**Flood Control Project Maintenance
Levee Inspections**
LMA District Cover Sheet
Spring 2018 Levee Inspection Results

Reclamation District No. 2063 Crows Landing

Spring 2018 Levee Inspection Results

Levee Inspection Report By Mile - Spring 2018

Photo 3 of 3 : UCIP_SP_2018_25025_45108.jpg

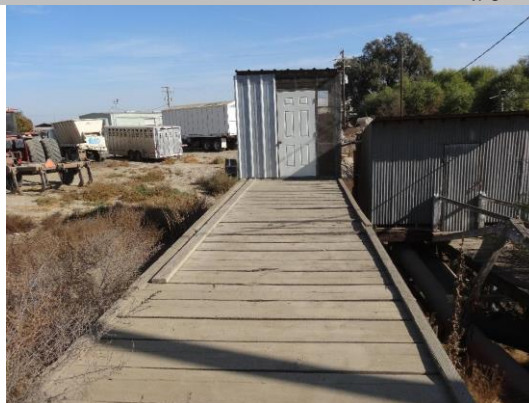
Comment Code						
Inspector Comment						
FS_ID:25025 DS_ID:24732 EP_NO: N/A Repair Type: Non-Urgent Crossing Status: Found UCIP Comments: - new pipe to pump.- overhead power line.- soil cover over the pipe seems not enough. FIELD_STRUCT_DESC: 24-inch steel drainage discharge pipe through the levee, immediately beneath the crown. A thin layer of dirt acts as cover for the pipe. Pump house on a steel structure in a drainage ditch on the landside (LS). Pump house and pipe on the LS look new. Old wooden walkway to the pump house. Three new air vents on the waterside (WS). Pipe opens on the WS. Exposed old pipe on the WS. FS Date: 11/6/2013

LS view: walkway to pump and pump house on levee slope.
